UNITED STATES PATENT AND TRADEMARK OFFICE

Office Action Summary

10/594,914

DETAILED ACTION

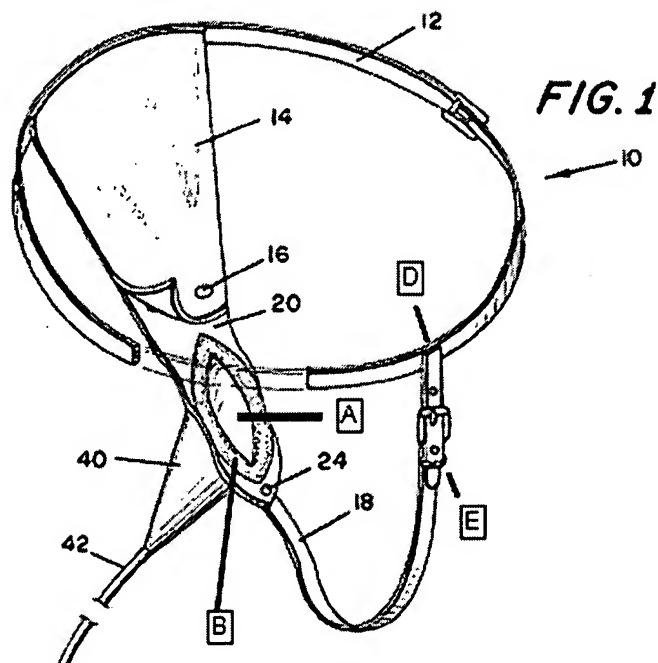
4. In Re claim 1, MAYHORN discloses a non-intrusive female urinary incontinence device comprising a flexible elastic strip (18) having a flat upper face and a lower face, an opening (A) being provided in the strip communicating between the upper and lower faces, a fluid collection means surrounding (B) the opening in a fluid tight manner on the lower face of the strip and means (24) for attaching the device to a supporting means (18), wherein the strip and opening are sized and shaped such that when it is stretch fitted over the external urogenital organs the labia minora extends through the opening and a fluid tight fit between the upper face of the strip and the flesh surrounding the labia minora and around the base of the labia minora is formed, such that in use urine is conveyed from the urethra, through the labia minora, into the collection means without leakage (See Fig. 1).

6. In Re claim 2, MAYHORN discloses a device wherein the fluid collection device comprises a funnel portion (40) the curved wall of which at an upper end extends

circumferentially from the surface of the oval region around the opening and curves inwards to a lower open end suitable for communicating with a collection vessel (See Fig 1).

7. In Re claim 8, MAYHORN discloses a device wherein the funnel is integral to the strip (Fig. 1).

8. In Re claim 10, MAYHORN discloses a device wherein the length of said straps is adjustable with respect to the waistband to allow for differences in size and shape of the user (See Fig. 1).

10. In Re claim 12, MAYHORN discloses a urinary incontinence device further comprising a waistband (12) and means (D) for attachment to the device (See Fig. 1).

11. In Re claim 13, MAYHORN discloses a device wherein the attachment means is adjustable to maintain a positive tension on the device when in use (See Fig. 1).

FIG. 1

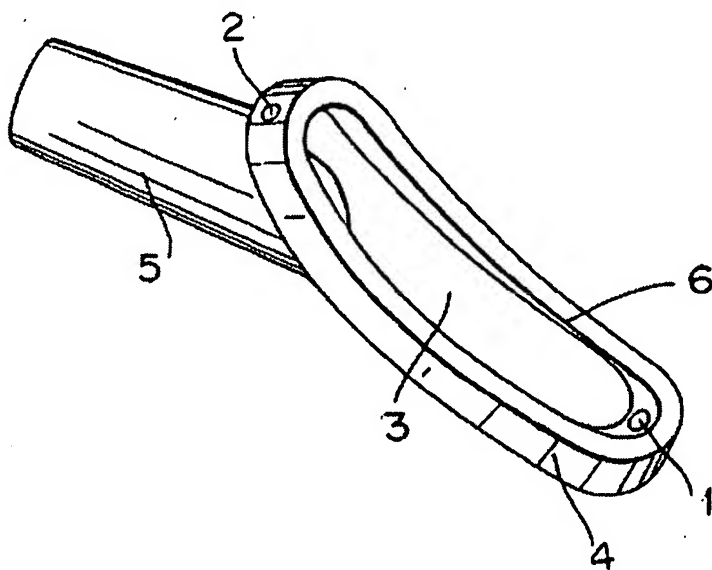
14. Birbara teaches that it is known to use the anterior surface of the wall of said funnel curves more sharply than the posterior surface, such that the lower opening at the base of the funnel lies in a lower plane than that of the opening in the strip (See Fig. 1).

15. It would have been obvious to one having ordinary skill in the art at the time the invention was made to modify the funnel of MAYHORN in view of Giacalone with the anterior surface of the wall of said funnel curves more sharply than the posterior surface, such that the

lower opening at the base of the funnel lies in a lower plane than that of the opening in the strip, as taught by Birbara because such modification would improve the hydraulic communication with a collection vessel.

FIG. 2

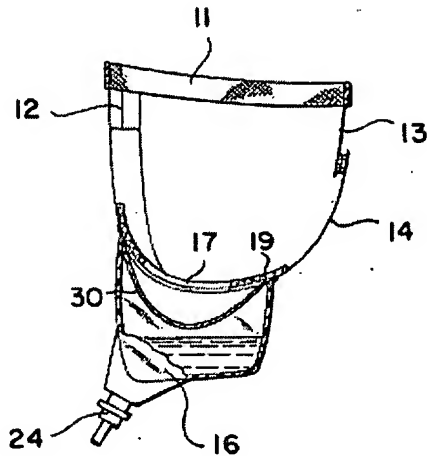
18. Bermingham teaches that it is known to use the double-walled funnel, the inner curved wall narrowing symmetrically and more sharply than the outer wall so that an internal opening is formed substantially parallel to and of smaller radius than the opening in the strip (See Col. 2, ln. 57-61; Fig. 2).

19. It would have been obvious to one having ordinary skill in the art at the time the invention was made to modify the device of MAYHORN in view of Giacalone with the double-walled funnel, as taught by Bermingham because such modification would prevent the urine from flowing back into the interior opening.

22. Bermingham teaches that it is known to use a cavity is formed between the posterior surface of the inner wall and the posterior surface of the outer wall such that, when the user is in a horizontal position, urine which has passed through the internal opening of the hel is prevented from flowing back into the cavity between said opening and the oval opening of the strip (See Col. 2, ln. 57-61; Fig. 2).

24. In Re claim 6, Bermingham discloses the device wherein the inner wall and outer wall are spaced apart such that urine in the cavity is prevented from flowing back into the interior opening ((See Col. 2, ln. 57-61; Fig. 2).

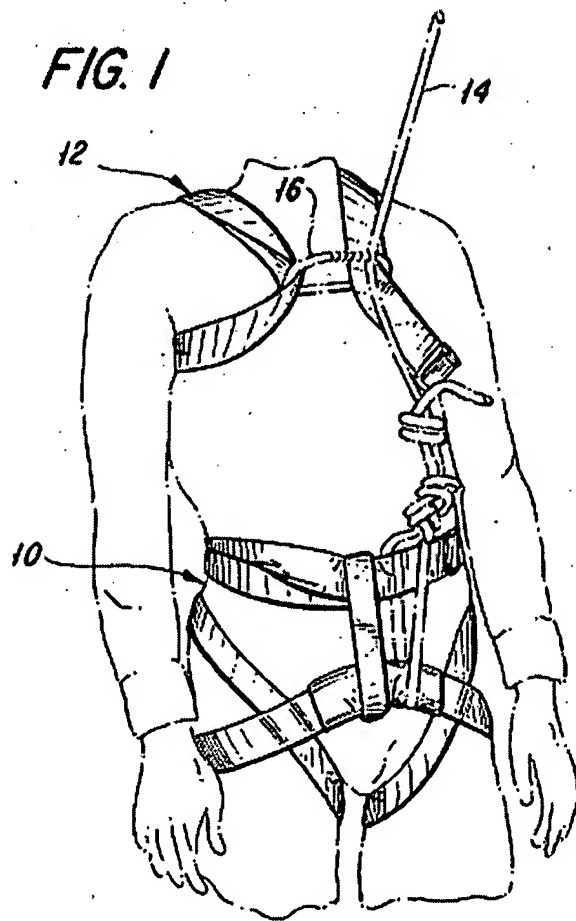
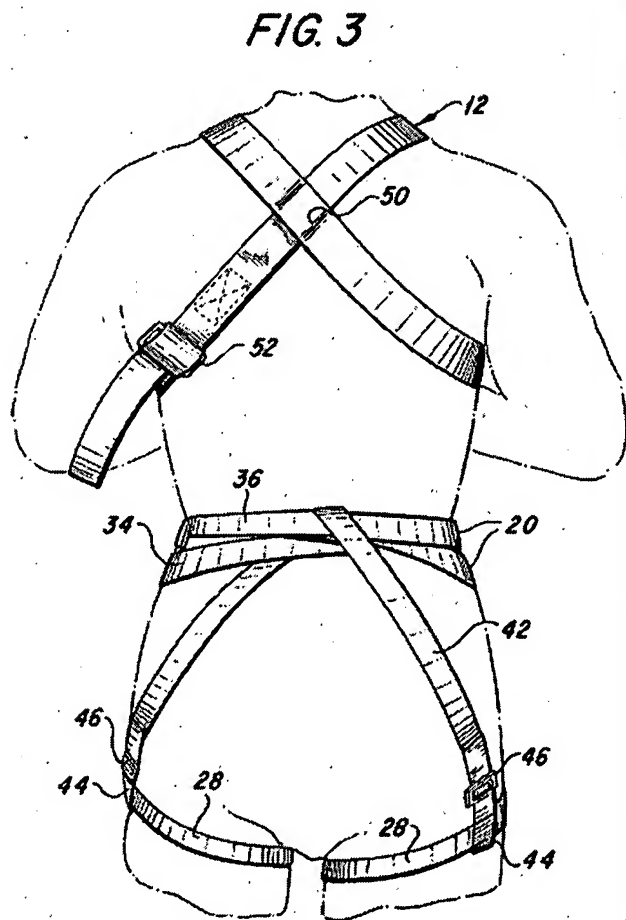
29. Markwell teaches that it is known to use a support system comprising of the strip comprises divergent elongated straps at the front and rear to provide anterior and posterior support straps for attachment to a supporting waistband (See Figs. 1 and 2).
